# Staff Summary Report

**SUBJECT:** Hold a public meeting for a Development Plan Review for **ACURA OF TEMPE** located at 7800 South Autoplex Loop.

**DPR07046** – Development Plan Review including site plan, building elevations, and landscape plan.

ACURA OF TEMPE

PRELIMINARY SOUTH ELEVATION  
SCALE - 1/8" = 1'-0"

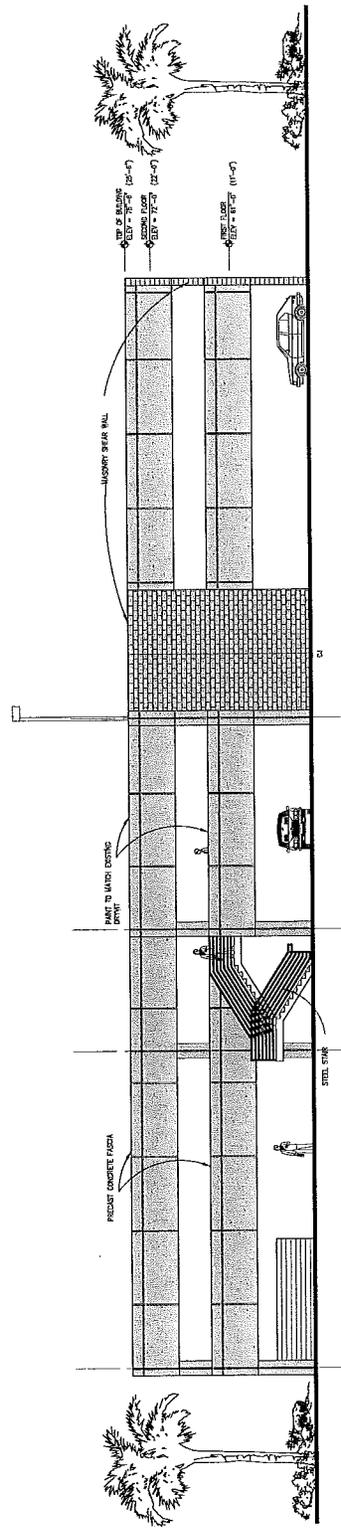
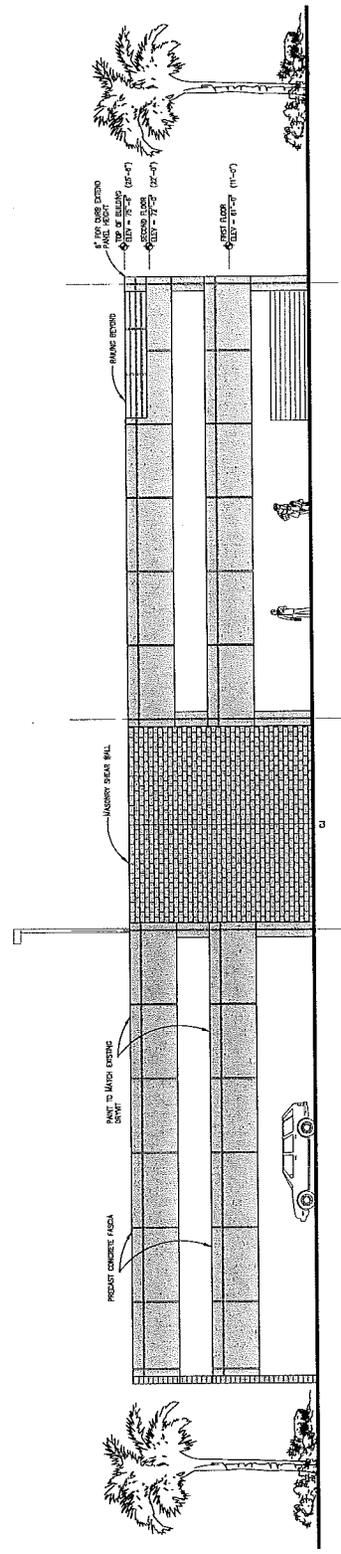
12. In lieu of light standards mounted to the roof level of the parking structure, provide canopies over the roof parking spaces and illuminate the roof spaces and drive aisles from the underside of the canopies. Design canopies to the following standards:

- a. Provide material and finish at upper side of canopy with light reflectance value of 75 percent or less.
  - b. Conceal lighting conduit to greatest extent possible in the folds of the canopy structure and finish conduit to match surroundings.

- c. Position light in canopy to direct light to interior of garage deck and away from perimeter.
  - d. Relate canopy in color and architectural detailing to the parking structure and dealership.

13. Conceal roof drainage system within the interior of the parking structure. Minimize visible, external features, such as overflows, and where needed design these to enhance the architecture of the building.

14. Incorporate lighting, address signs, incidental equipment attachments (alarm klaxons, security cameras, etc.) where exposed into the design of the building elevations so that the architecture is enhanced by these elements.
  15. Exposed conduit, piping, etc. is not allowed unless a creative conduit surface design that compliments the architecture is reviewed and approved by the Development Review Commission.
- Measure height of parking structure from top of curb on Autoplex Loop opposite the center front of the property.
  - Provide colors and materials with a light reflectance value of 75 percent or less. Specific colors and materials exhibited on the materials sample board are approved by planning staff. Submit any additions or modifications for review during building plan check process. Planning inspection staff field verifies colors and materials during construction.

20. For the parking structure, provide one dealership address sign on the south elevation, centered on the masonry shear wall near the southwest corner, and one on the east elevation, also centered on the masonry shear wall. Approximate the height of these signs with that of the existing address signs on the dealership.
    - a. Conform to the following guidelines for building address signs:
      - 1) Provide street number only, not the street name.
      - 2) Compose of 12" high, individual mount, metal reverse pan channel characters.
      - 3) Adjust locations on building so sign is unobstructed by trees, vines, etc.
      - 4) Do not affix a number or letter to the parking structure that might be mistaken for the address.
- Follow requirements of ZDC Sec. 4-903 (A) for address sign illumination and background contrast requirements.

GROUND FLR.  
**A5.1**

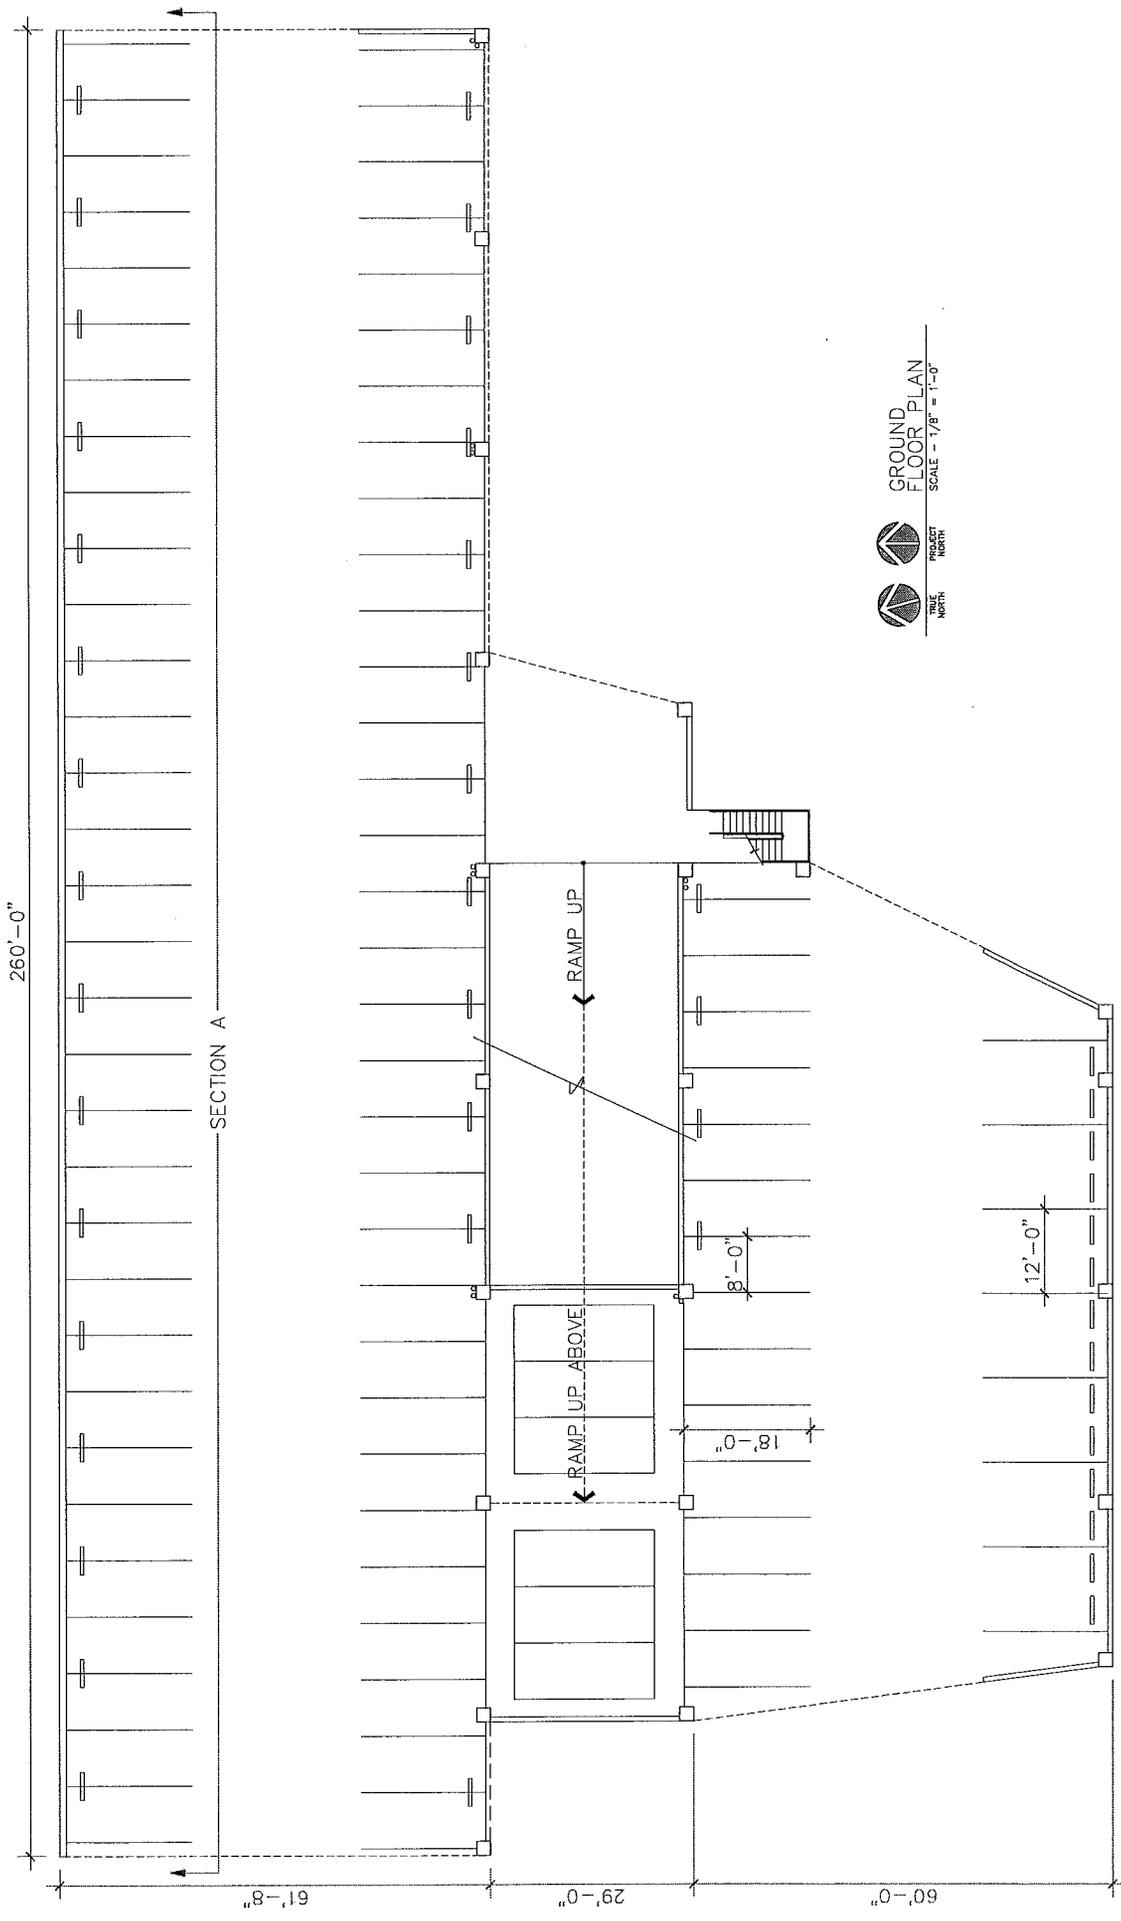
8. Provide primary and secondary striping of parking structure spaces as follows:
  - a. Provide primary striping in the parking structure at 8.5 ft. x 18 ft. Indicate this quantity of parking in the Project Information for the parking structure. Conform to ZDC Sec. 4-601 through 4-606 in every aspect of the primary parking layout.

- b. Provide secondary striping or other demarcation in a different color with numbers for inventory. The secondary striping or demarcation may include tandem parking, as is indicated on the ground floor and roof plans. This tandem parking will not require a use permit because the quantity of parking and the planning review is based on the primary parking. The secondary striping or demarcation may be at the size stipulated by the dealership.

PROJECT NO. 030607  
 ROOF PLAN  
**A5.3**

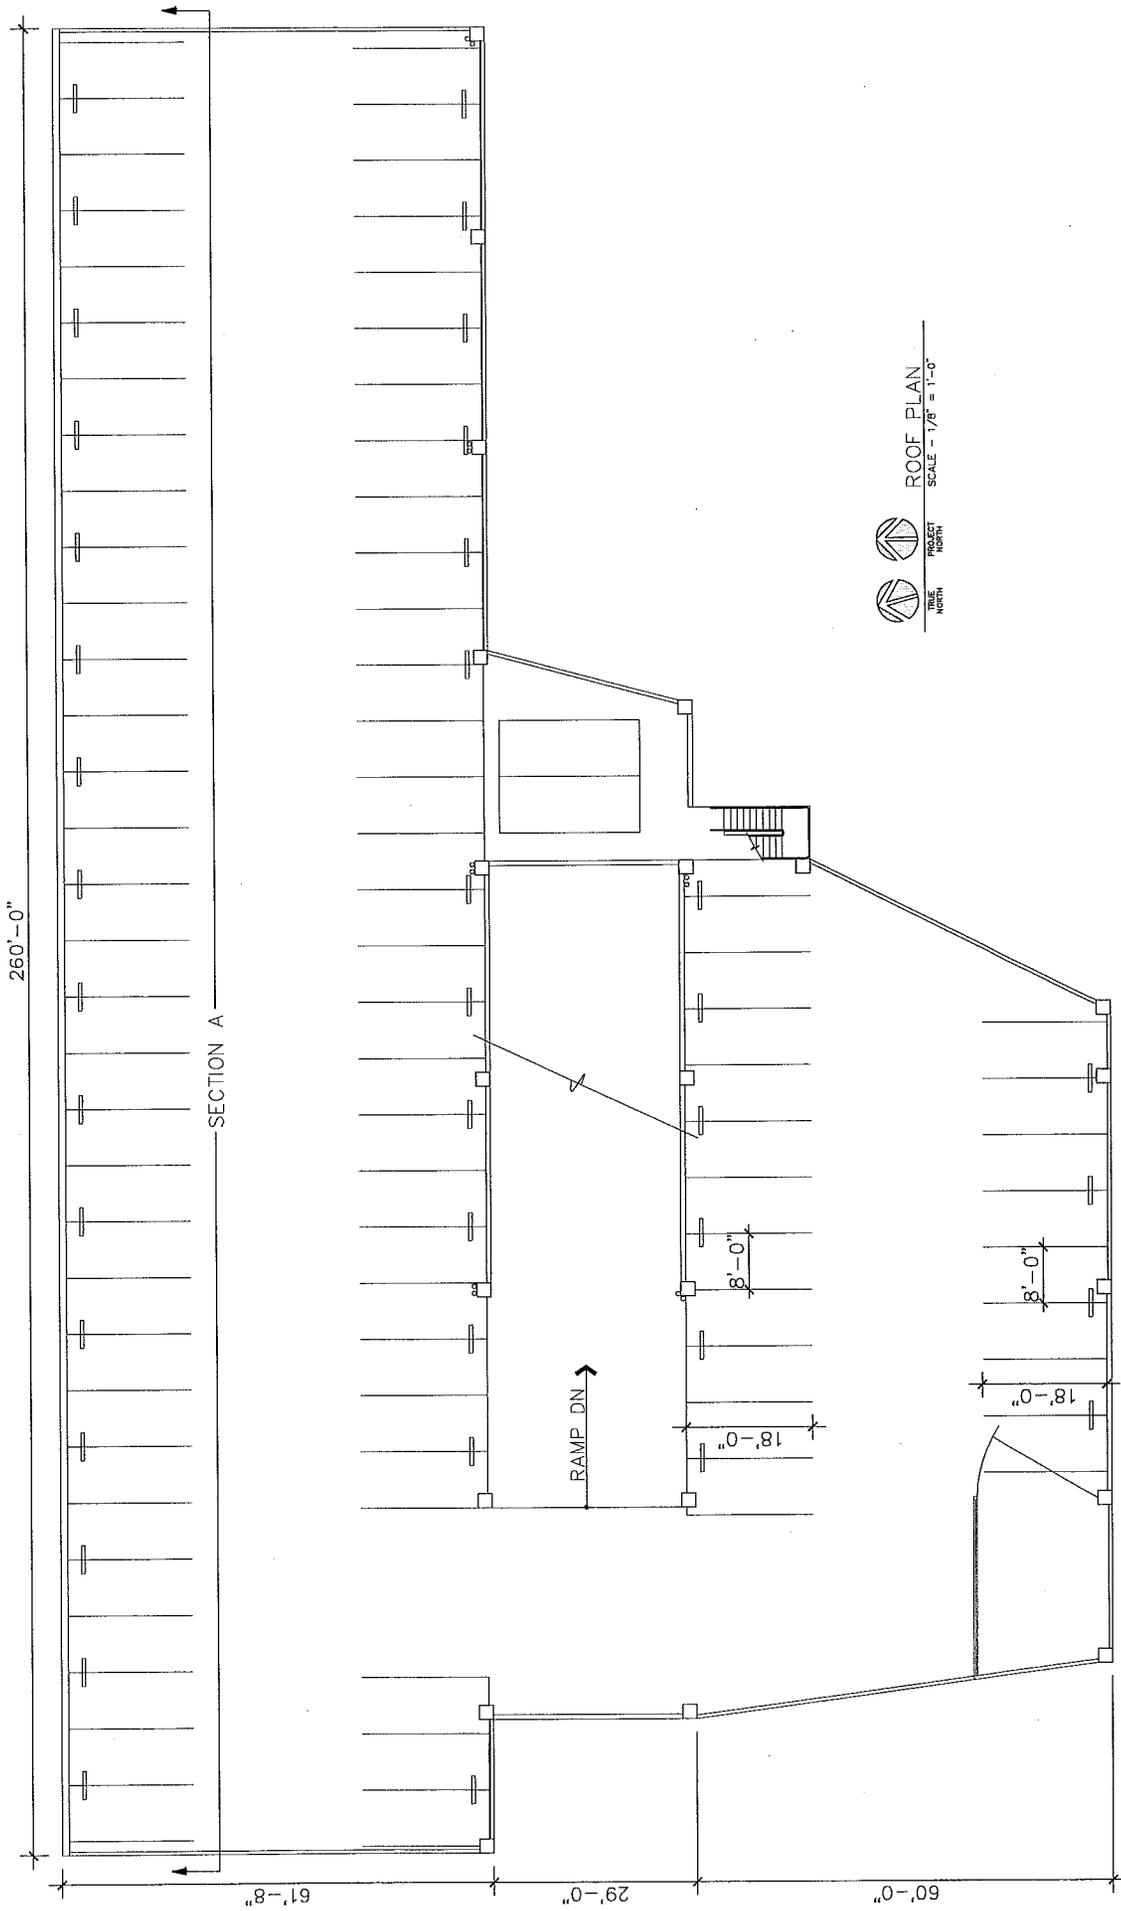
9. Provide complete design for the fenced and gated yard in the southwest corner of the parking structure roof plan. Include the following: height of enclosure and whether enclosure has a roof. Indicate the material and finish of the enclosure fence. Provide a semi-opaque screen adjacent to parking and drive aisle to maximize visual surveillance. Describe the purpose of the enclosure. Swing gate into a drive aisle or an area not demarcated with primary parking spaces. Consider relocation of this enclosure to the east area on the roof opposite the head of the drive ramp.

**RETENTION VOLUME CALCULATIONS**

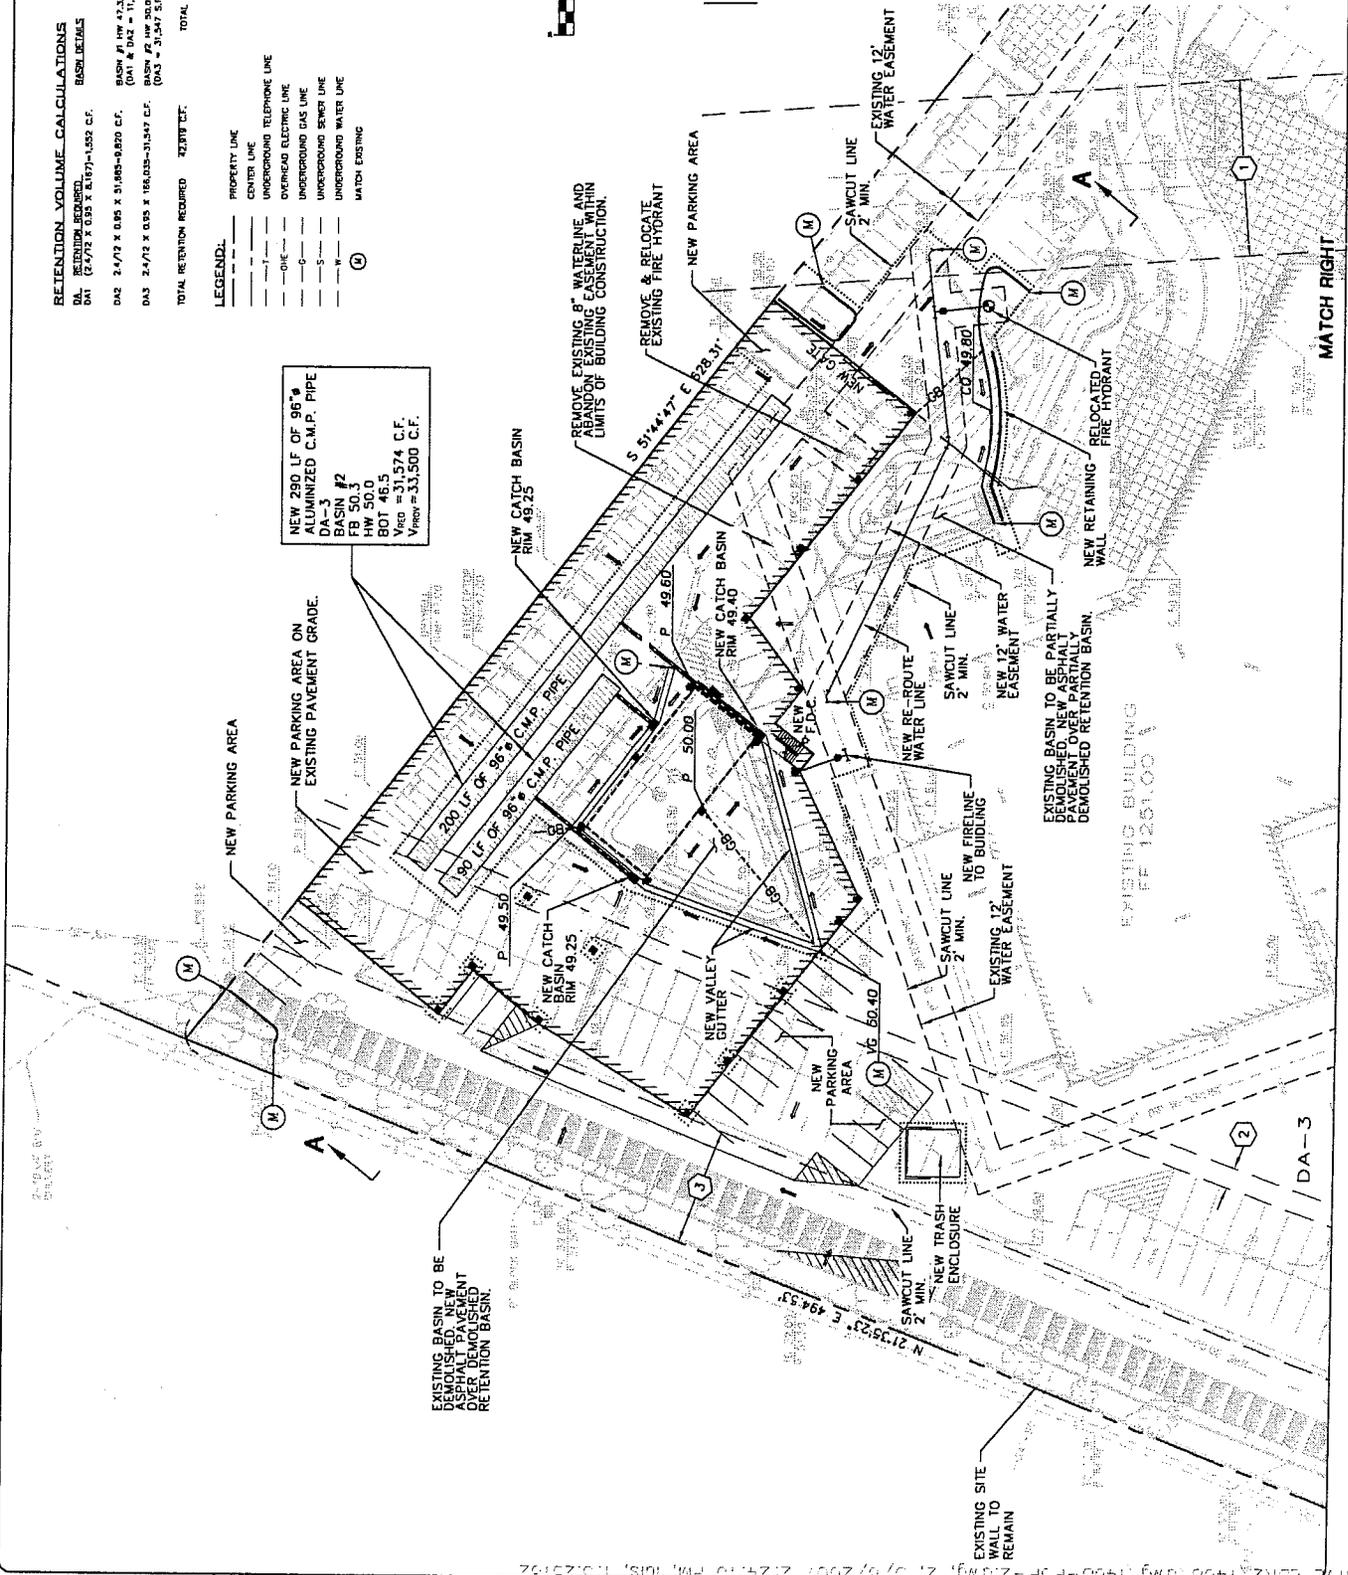
3. Modify storm water retention system to accommodate the parking structure addition. Incorporate the following Engineering Division comments (Chris Kabala 480-350-8341) into the retention system and related site plan modifications.

- a. Existing retention basin between east end of parking structure and service reception canopy will require a drywell if basin depth is greater than 12".

- b. Design parking structure so existing drywells under ramp and proposed tanks under north drive aisle are accessible to maintenance trucks.
  4. Gate to parking structure and gate to service yard:
